## Product Change Notification

PCN #: 20210128-01

**Change Title:** Modification of the AZ943 series relays.

**Products Affected:** AZ943 series

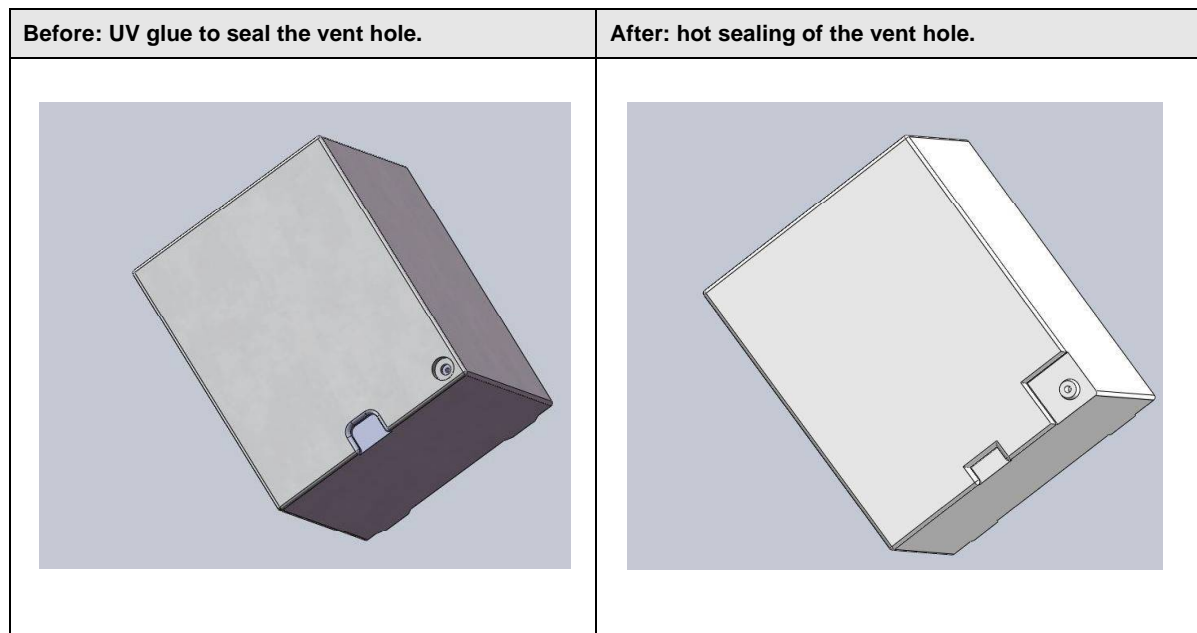
- New sealing concept for the relay
- Improvement of production efficiency
- The use of UV glue for environmental reasons is reduced

Switching from UV glue sealing of vent hole for sealed versions of AZ943.

This change has no further consequences for the product. The change does not affect any structure and performance of the product. This change does not affect the certifications.
